**RE: Conservation Commission Meeting, May 4, 2021  
1325 Washington Street NOI**

Project  
**HANOVER WEYMOUTH RESIDENTIAL DEVELOPMENT**  
 #1325 WASHINGTON STREET, WEYMOUTH, MA

Drawing Title  
**RESOURCE AREA AND BUFFER EXHIBIT PLAN**

Drawing No.  
**R-1**

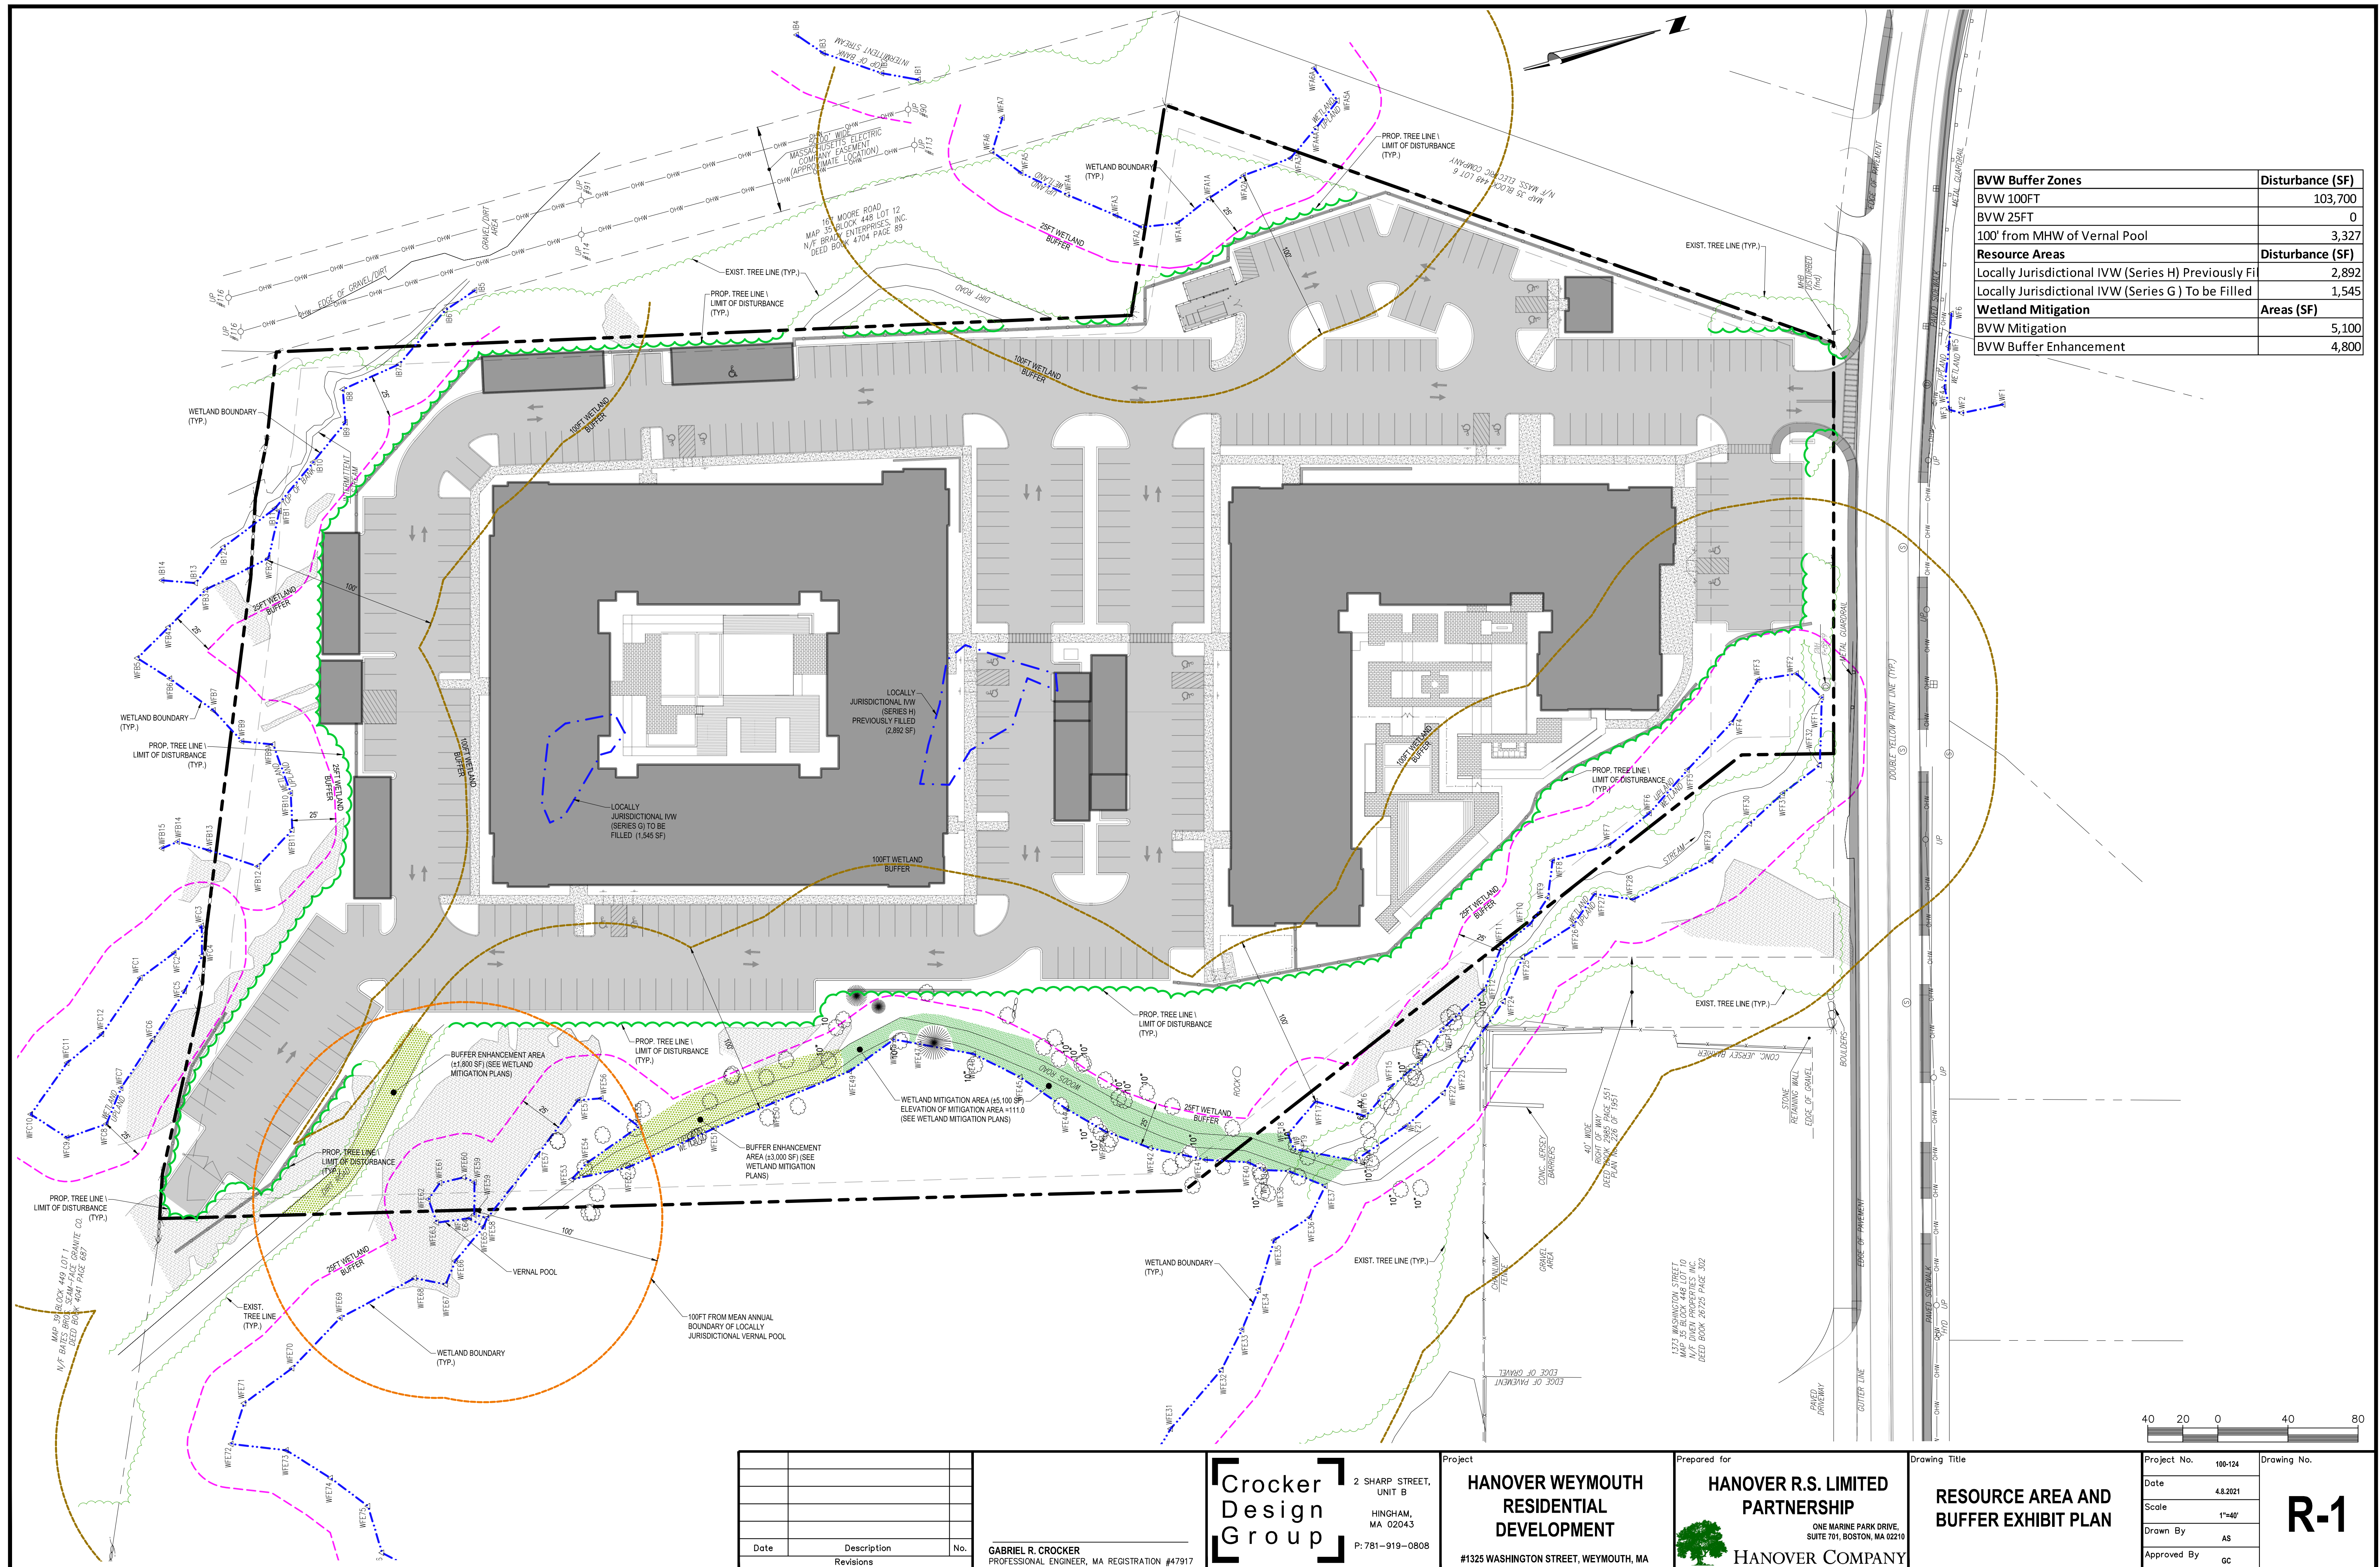
Comment 3: Resource areas and buffer zones need to be shown more clearly on the plans. The 25, 50 and 100-foot buffer zones to wetlands should be shown. Vernal pool resources are protected under the Weymouth Wetlands Protection Ordinance with a 200-foot jurisdictional area. There is an inner 100-foot vernal pool resource area and an outer 100-foot vernal pool buffer area. These vernal pool areas should be shown on the proposed plans.

Comment 4: Resource area and buffer zone impacts should be quantified. How much disturbance is being requested in the 25, 50 and 100 foot buffer zones? How many mature trees are proposed to be removed?

Comment 5: During the ANRAD review, the Commission identified – and the ORAD plan shows – “local-only” wetland resource areas that had been filled without authorization. The submittal should include a quantification of the resource areas filled and the mitigation being proposed to compensate for this unauthorized work.

Comment 6: Plans should be provided that clearly show the extent of proposed clearing. Plans should also show areas cleared prior to authorization. Wooded areas to be cleared should be quantified, in size of area and number of trees greater than 6 inches in diameter.

**CDG Response: The plans submitted include the 25-foot and-100-foot buffer zones on Sheets C-1 (Overall Layout Plan) with labels. We have also prepared the attached exhibit sheet R-1 Resource Area and Buffer Exhibit Plan for your use which identifies the resource areas delineated and approved on the ORAD, as well as the Bordering Vegetated Wetland (BVW) buffer zones. The Exhibit also shows the 100-ft vernal pool resource area. We have not included the 50-foot wetland buffer as it does not appear to apply to this multi-family, mixed-use project.**

**CDG Response: We have provided a breakdown/quantification of the proposed area of work within the 25 and 100-foot buffer zones on the attached sheet R-1 Resource Area and Buffer Exhibit Plan. It is our opinion that the 50-foot buffer zone referenced does not apply to this project and as such, we have not included in the attached Resource Area and Buffer Exhibit Plan. The existing trees within the proposed limit of work will be removed.**

**CDG Response: A table is provided on the attached sheet R-1 Resource Area and Buffer Exhibit Plan. Locally jurisdictional IVW “H” series was previously filled. Locally jurisdictional IVW Series “G” is proposed to be filled. The Total square footage of the two locally jurisdictional IVWs is 4,437 square feet. The local bylaw and regulations require 2:1 mitigation, or a total of 8,874 square feet of mitigation required. The project includes 5,100 square feet of wetland replication and 4,800 square feet of buffer enhancement in close proximity to the locally jurisdictional vernal pool, which totals 9,900 square feet, exceeding the 2:1 mitigation required under the local bylaw and regulations by 1,206 square feet.**

**CDG Response: The plans identify the proposed limit of clearing (i.e. Proposed Tree Line) on Sheet C-1 Overall Layout Plan. Sheet C-5 also identifies the limits of erosion controls proposed around the project. Sheet R-1 Resource Area and Buffer Exhibit Plan identifies the proposed tree line in a colored exhibit for clarity. Existing trees within the identified tree line are proposed to be removed.**
